Rezoning application, Ravenswood

**Report and recommendations of the
Environmental Protection Authority**

**Environmental Protection Authority
Bulletin 458
November 1990**

**Rezoning, residential development to
residential R-10 and caravan/chalet park
Lot 6 and Pt Lot 64, Lloyd Avenue, Ravenswood**

Figure 1: Existing scheme map

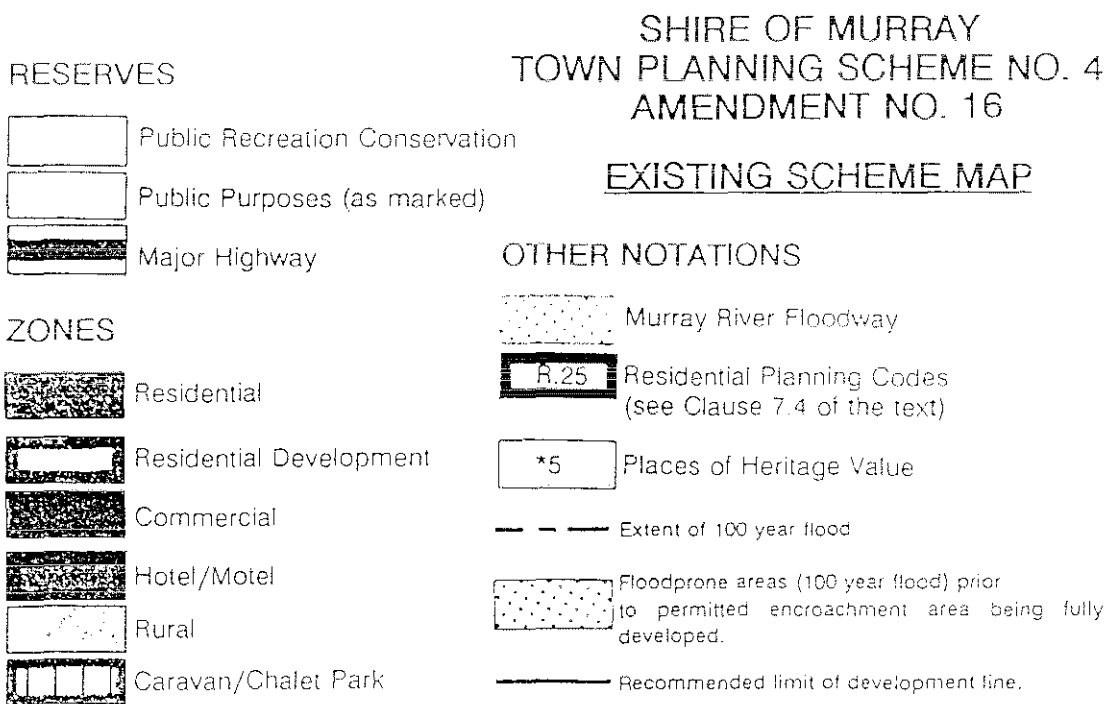
As indicated by Figure 1 over half of the area proposed to be rezoned is in a floodprone area. Based on the Murray River Flood Study, the Water Authority recommends a minimum floor level of RL 4.95 m AHD for adequate protection of buildings. As indicated in the description of proposal some minor filling is necessary.

The Authority considers that when development approval for the Chalet/Caravan Park is sought the Shire of Murray should ensure that no permanent structures such as chalets or structural appendages to caravans are permitted to be erected on sites which are below the 1 in 100 year flood level of RL 4.95 m AHD.

Figure 3: Proposed layout of the caravan/chalet park

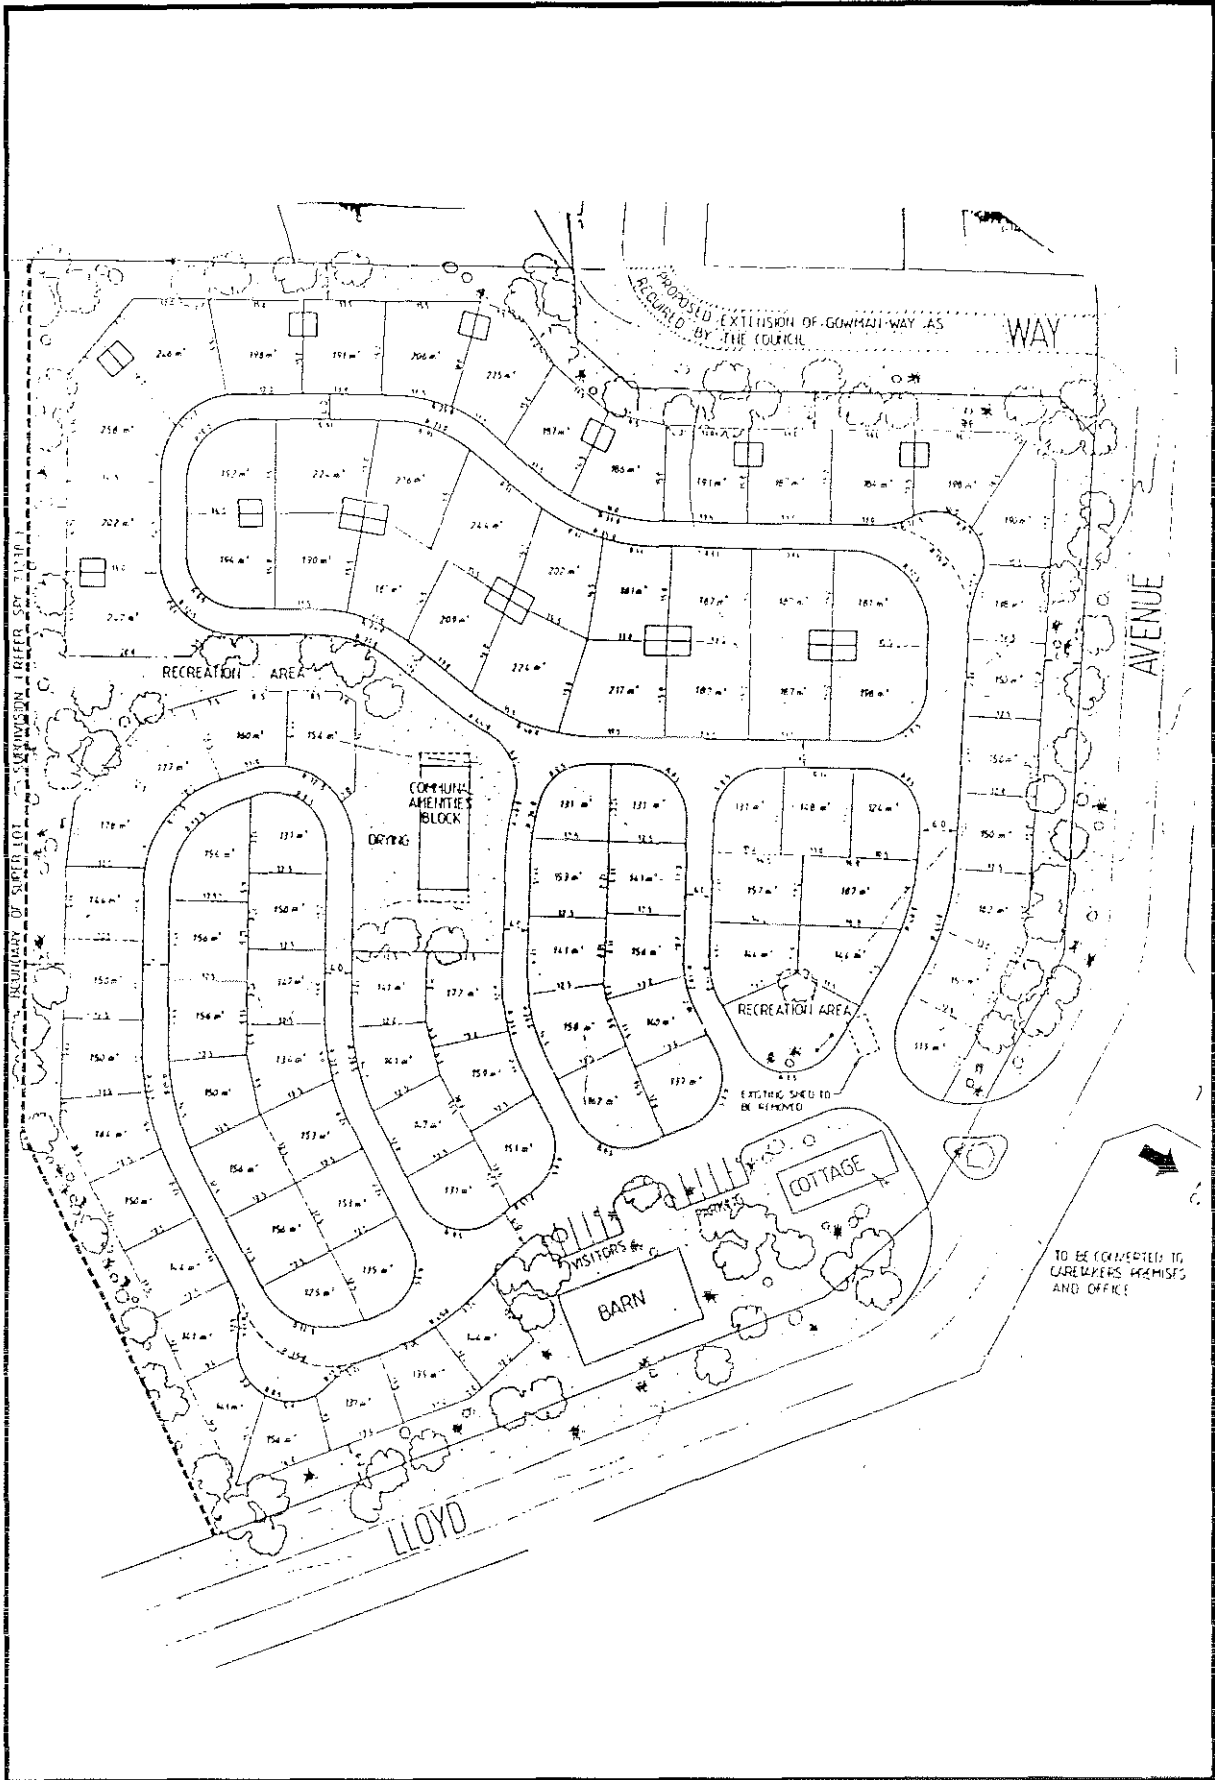
Figure 3 is a copy of a plan showing the proposed layout of the caravan park and the existing ground level contours. Clean fill will be used to bring buildings such as the communal amenities block and private amenities blocks in the north-east corner to meet minimum floor levels recommended by the Water Authority.

The Authority understands that only minor filling is necessary in the Caravan/Chalet Park. Filling should be done in a manner that ensures it is not unsightly and ensures that the likelihood of erosion of the fill is minimised.
